LOWER SALFORD TOWNSHIP  
BOARD OF SUPERVISORS MINUTES  
February 5, 2025

**RESOLUTION NO. 2025 - 06**

**FINAL LAND DEVELOPMENT APPROVAL**

Reference: Final Land Development Review  
196 Main Street - Mainland V, LLC  
TMP No. 50-00-02014-00-6

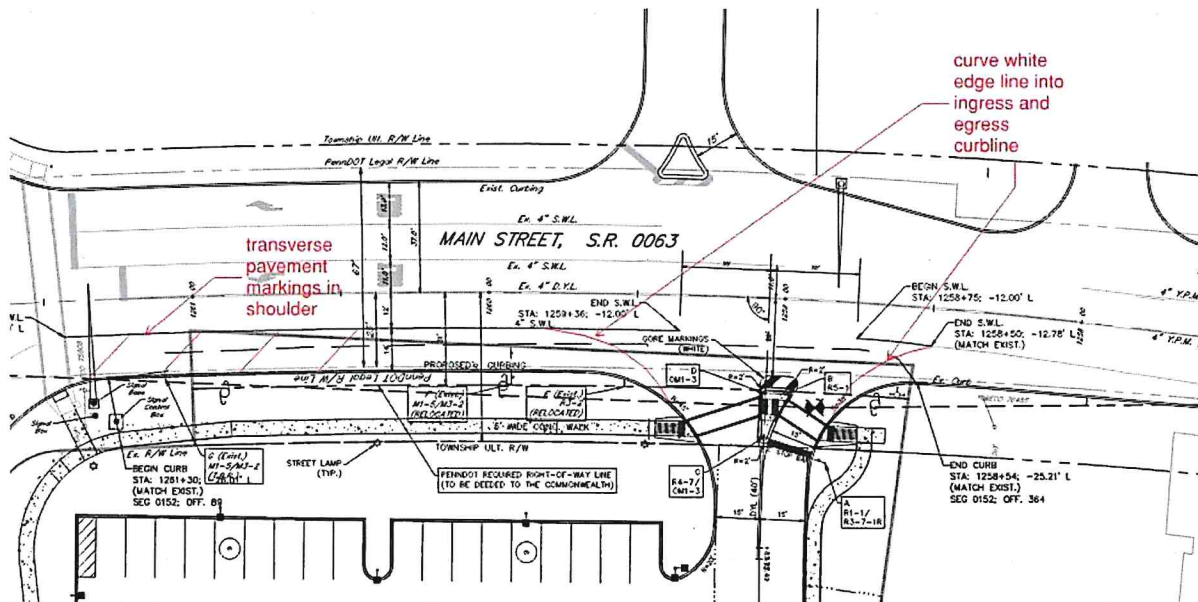
13. The sidewalk and curbing along the Quarry Road site frontage should be extended to the western property line and the sidewalk along the Main Street (S.R. 0063) site frontage should be extended entirely to the southern property line as required by *Section 142-41 of the SALDO*. The sidewalk appears to end short of each property line. ***The applicant's engineer indicates in its response that a partial waiver is being***

**requested for this condition to allow adequate room for grading and that a written request for this waiver has been provided and discussed with the Board of Supervisors.** It should be noted that the plans do not list this waiver request, and our office received an updated waiver request letter dated January 24, 2025 (following the plan submission). It is recommended that the sidewalk connections at each property line be extended to the property line, however it is noted that the connections are located within the Ultimate R/W and therefore, a deferment due to grading could be considered until such time that they are deemed necessary by Lower Salford Township. A note should be added to the plan.
